# UNITED STATES PATENT AND TRADEMARK OFFICE

APPLICATION NO.	FILING DATE	FIRST NAMED INVENTOR	ATTORNEY DOCKET NO.	CONFIRMATION NO.
10/658,910	09/10/2003	Tom Blanchester	TLA03,05	3610

<b>Office Action Summary</b>	<b>Application No.</b> 10/658,910	<b>Applicant(s)</b> BLANCHESTER, TOM	
	<b>Examiner</b> Stephanie E. Tyler	<b>Art Unit</b> 3754

Detailed Action

FIG. 1

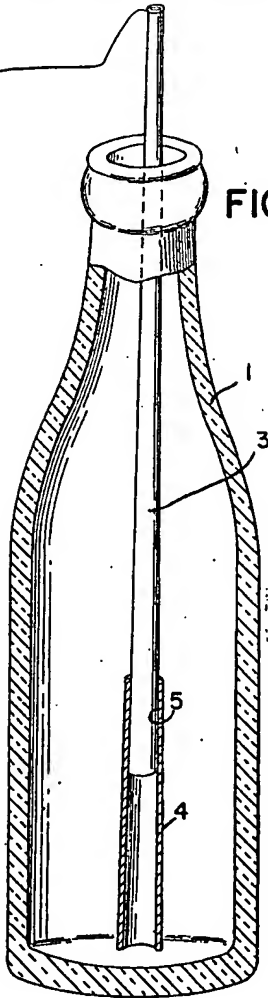
Jarbeau teaches a beverage dispensing device in figure 3 where the second straw (9) has a radial thickened portion (see fig.1 for top of tube (9))<sup>1</sup> and the first straw (11) has a waist at an upper end portion (12) that bears against the thickened portion (10) of the lower portion of the second straw for the purpose of "restraining from becoming separated from one another" (col. 2,lines 14&15).

Thickened  
Portion
